NEW MEXICO OIL CONSERVATION DIVISION

ADMINISTRATIVE APPLICATION CHECKLIST

Re: Amendment to C-108 Application to Inject
COG Operating LLC
Charger 29 Federal #1 SWD
Township 23 South, Range 30 East, N.M.P.M.
Section 29: 1780' FNL & 810' FWL
Eddy County, New Mexico
SWD Order 630, API 30-015-28808

COMPANY: Santa Fe Energy Resources Inc
 WELL: Charger 29 Federal No. 1
 FIELD: Undesignated Group 4
 COUNTY: Eddy STATE: New Mexico

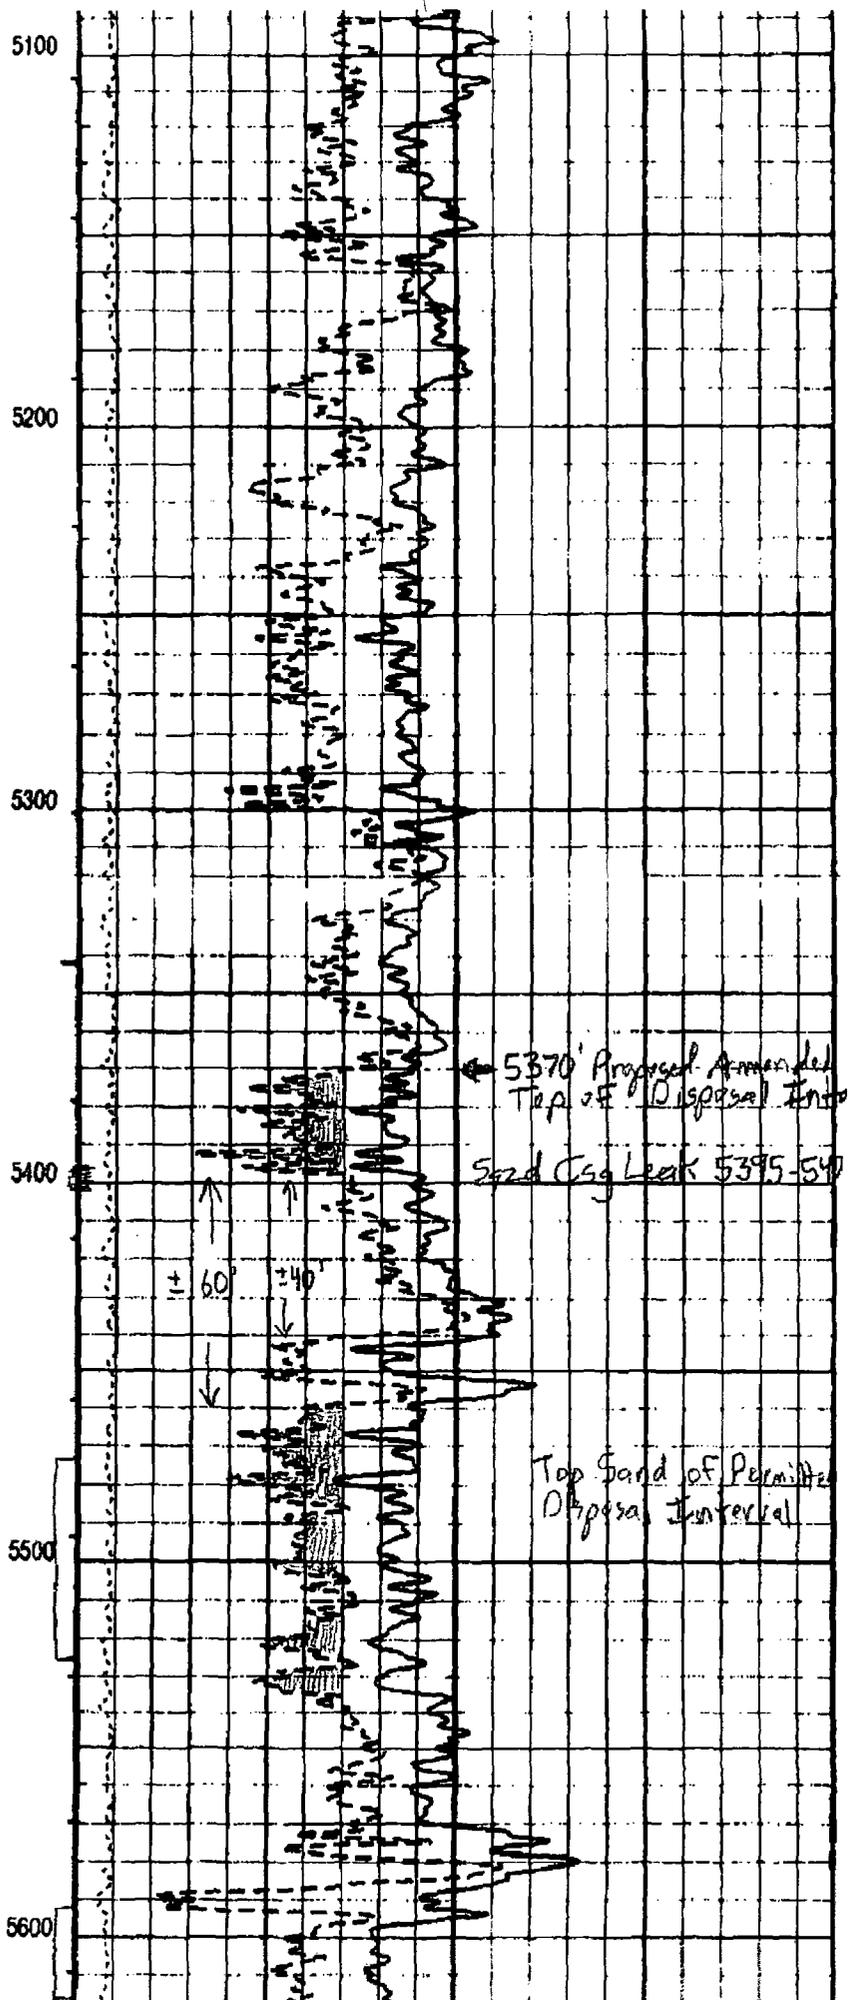
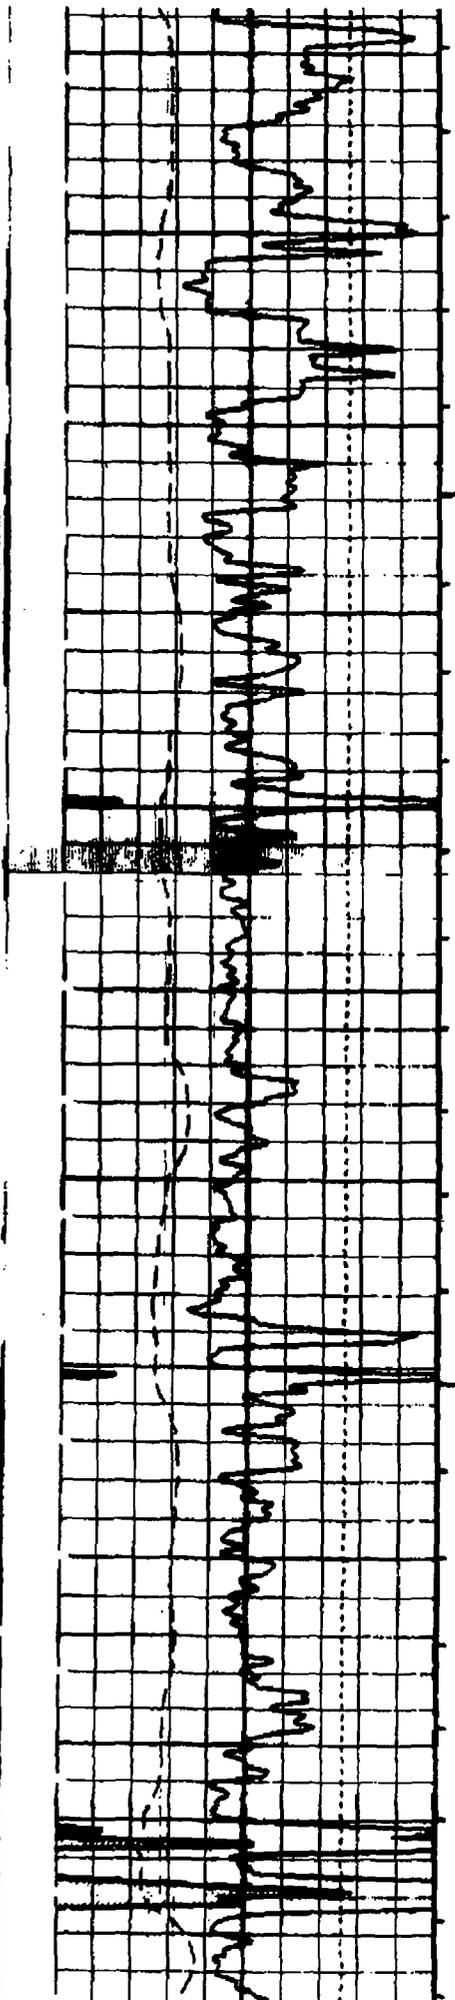
This well has a casing leak from 5395' to 5402' which has been cement squeezed in the past, but is likely to become chronically communicated with the injection interval 77' down hole resulting in frequent workovers to re-squeeze the casing leak. We propose to include the casing leak interval in the amended injection interval so we can put the packer above the casing leak and isolate it below the packer. We propose to decrease the maximum allowable injection pressure to 1074 psi. The rest of the original C-108 submitted by Maralo is still applicable and unchanged.

The nearest shallow Delaware Sand production occurs from 4068' to 4107' in Section 30 to the west of this well. A section of the porosity log is attached showing the proximity of the porosity zone where the casing leak is relative to the porosity zone where the top of the currently approved injection interval is.
